Amendments to the Drawings:

Serial No.: 10/666,342
Art Unit: 2682

Attorney's Docket No.: H0004415-1246
Page 13

FIG.
Figure 15

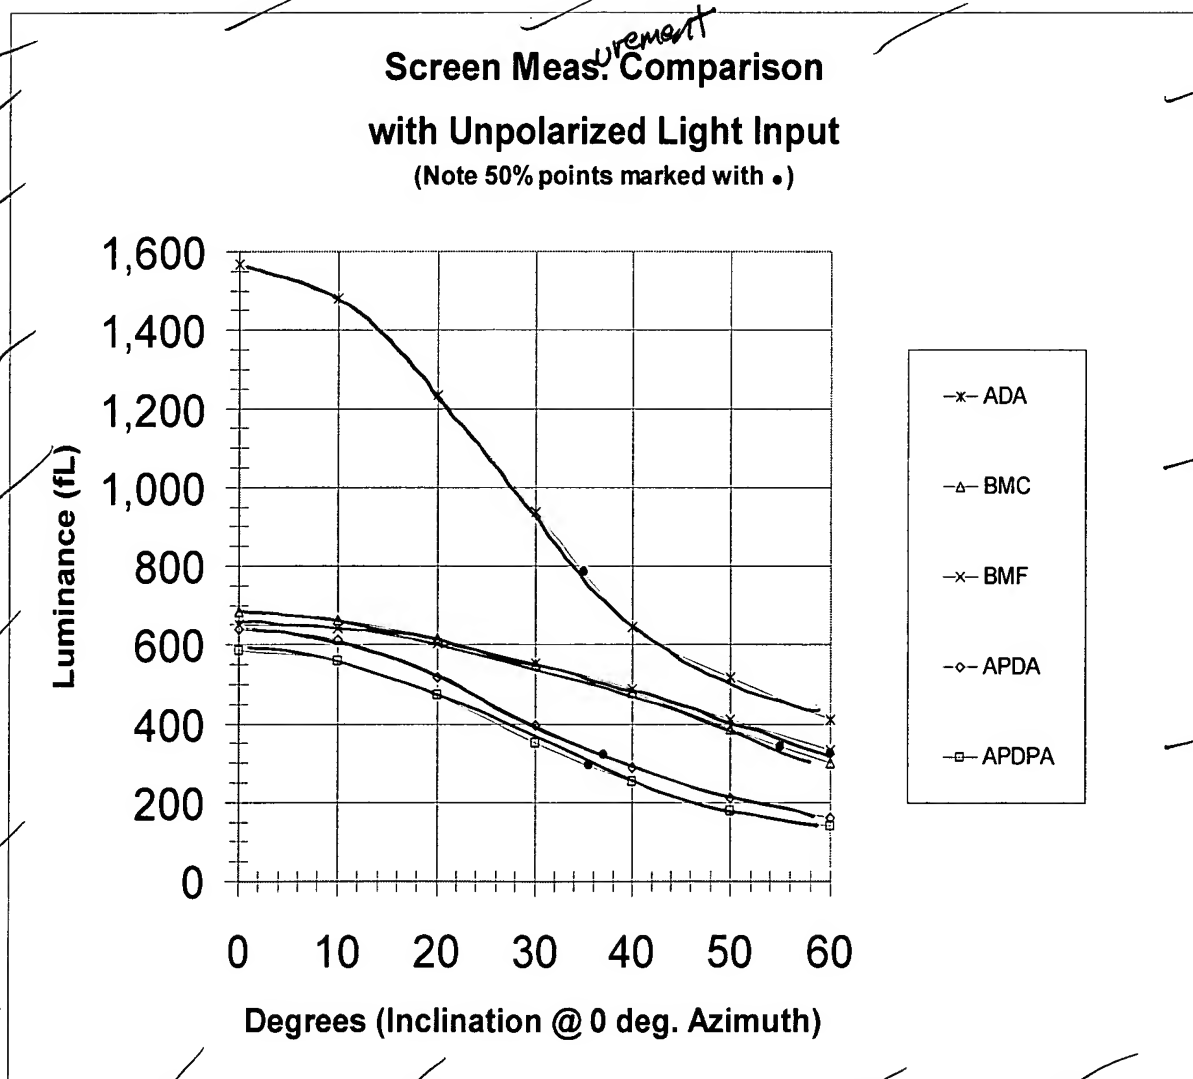
As required by the Office Action, replacement sheets for Figures 15-17 and 20 (as well as new Fig. 21) are being submitted herewith for entry. Also submitted are Annotated Marked-up Drawings that show how Figures 15-17 and 20 have been modified. It is noted that the main modification in the graphs of Figures 15, 16 and 20 is that the lines have been darkened.

FIG
Figure 16

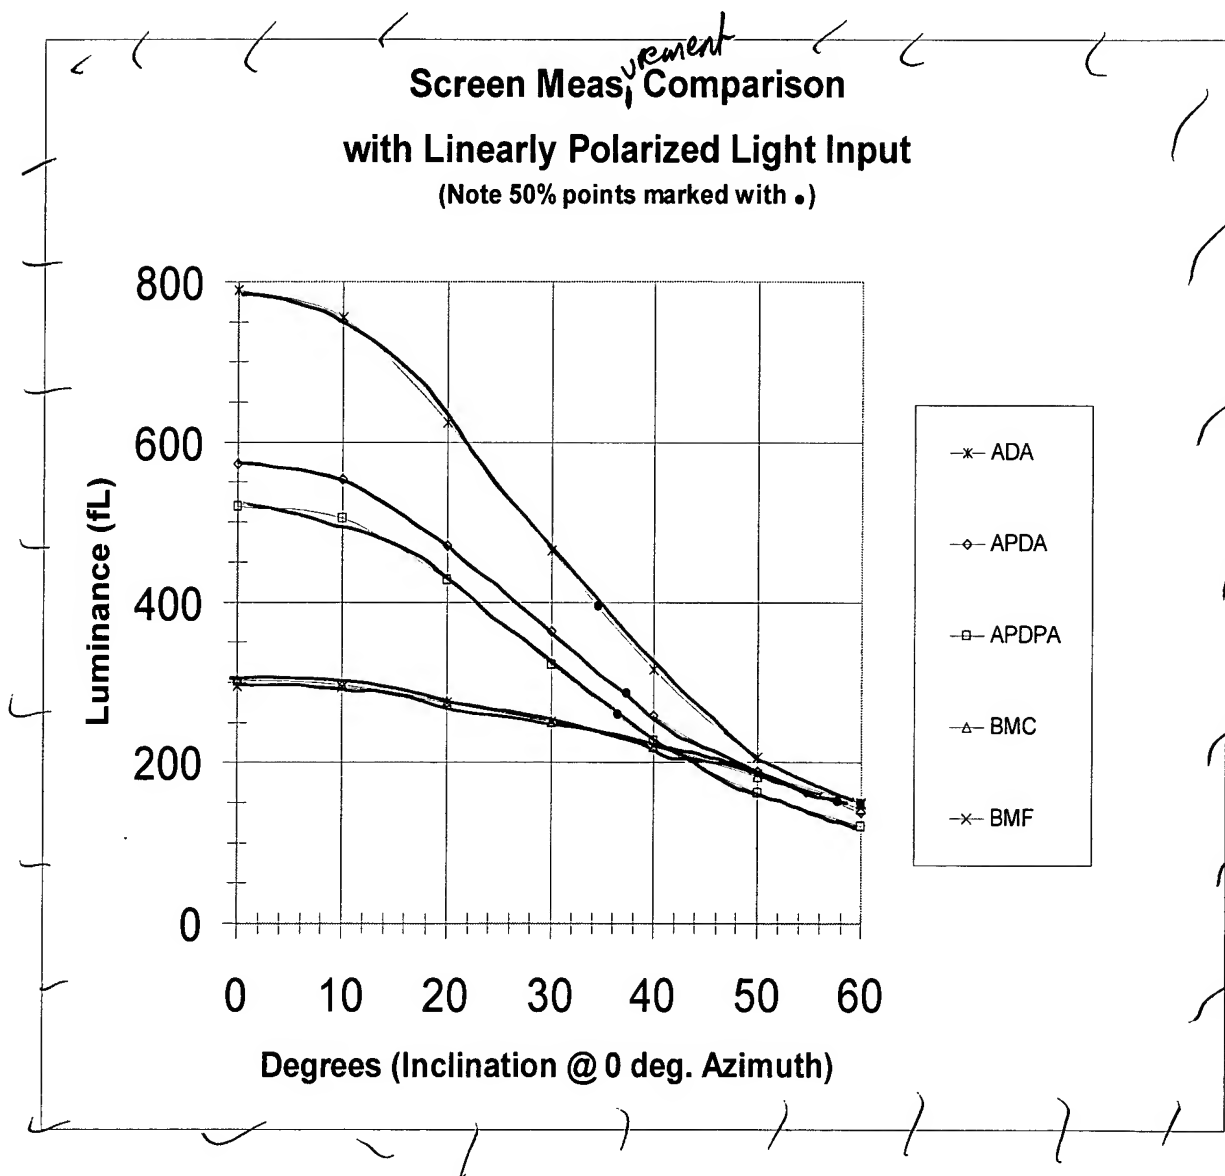
~~Screen Measurement Comparisons
with Polarized Light Input~~

FIG. 17

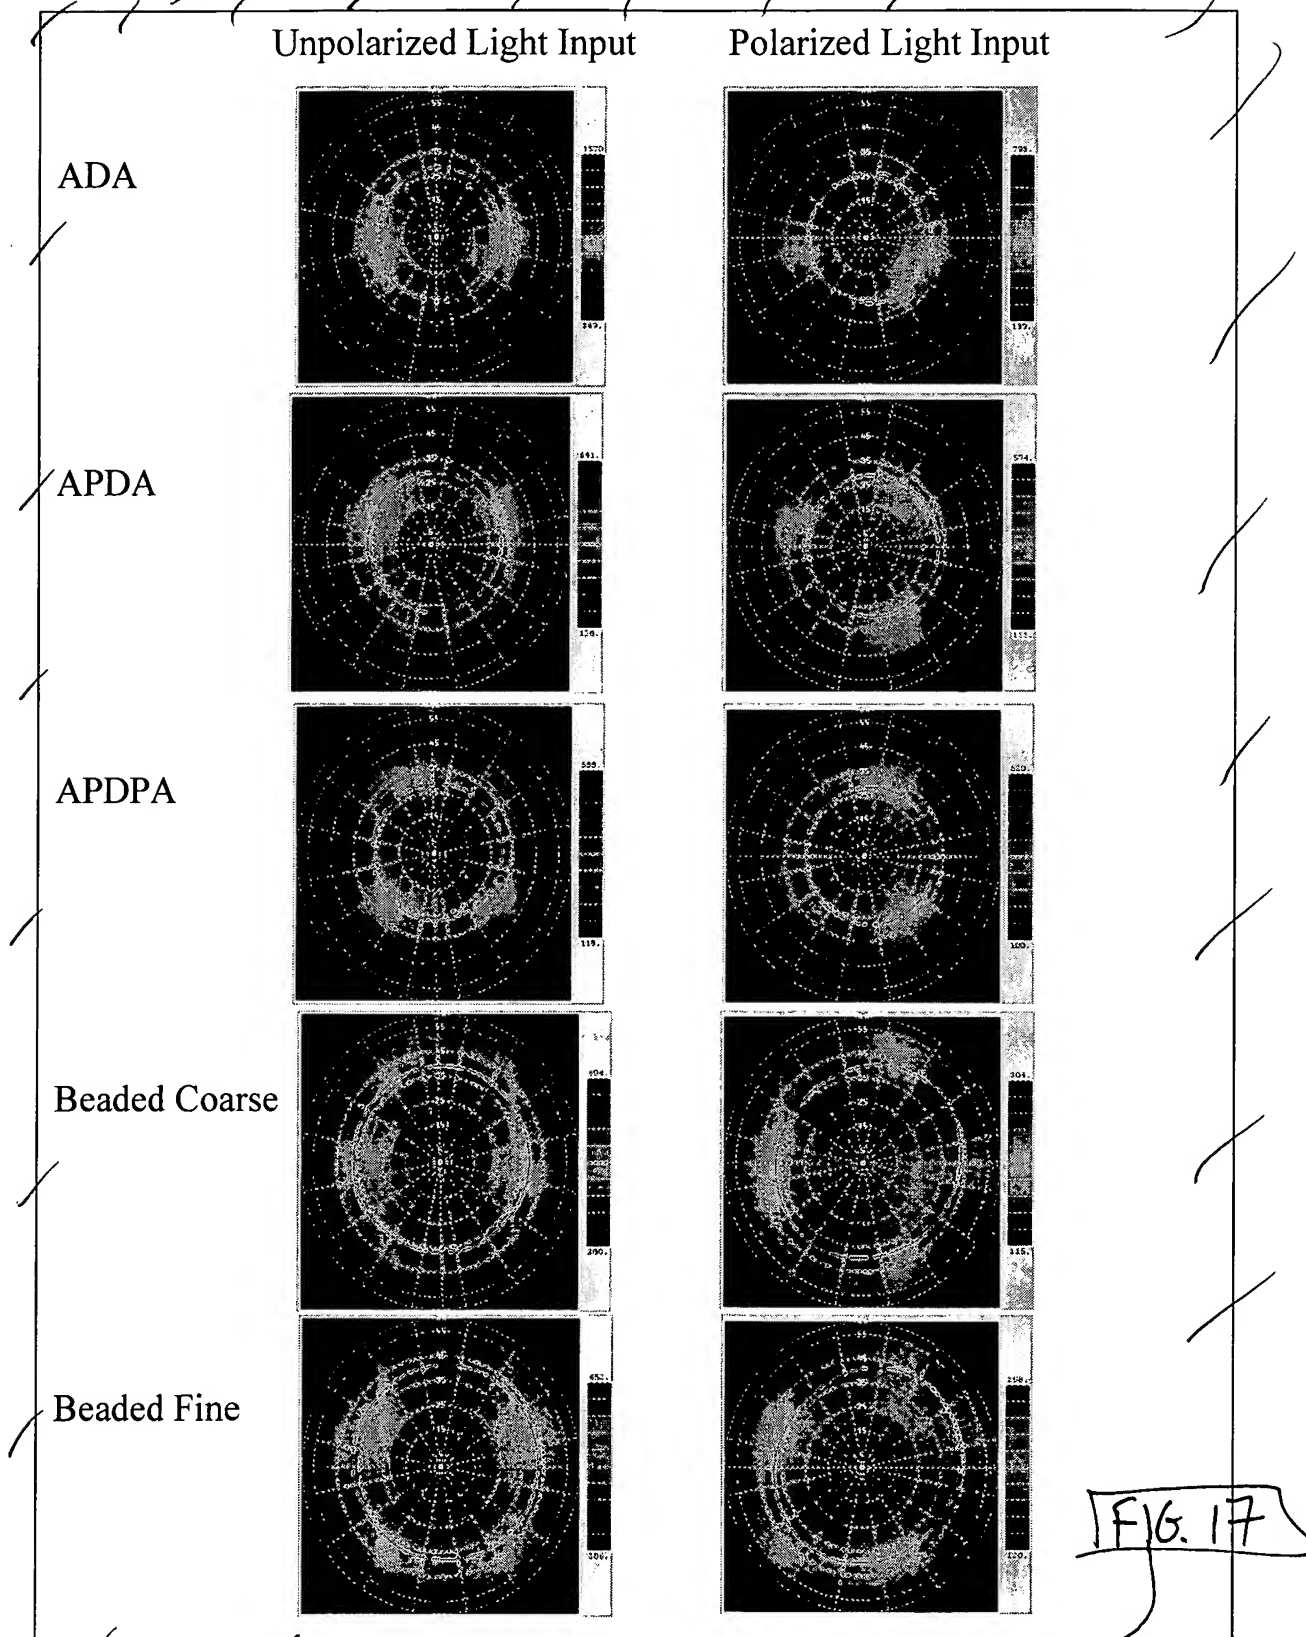
The attached sheets of drawings include changes to Figs. 15-17 and 20, and a new Fig. 21. These sheets, which include Figs. 15-17, 20 and 21, replace the original sheets including Figs. 15-17 and 20. Annotated Marked-up Drawings are also attached. Comments regarding these drawings can be found below in the Remarks section of this paper.
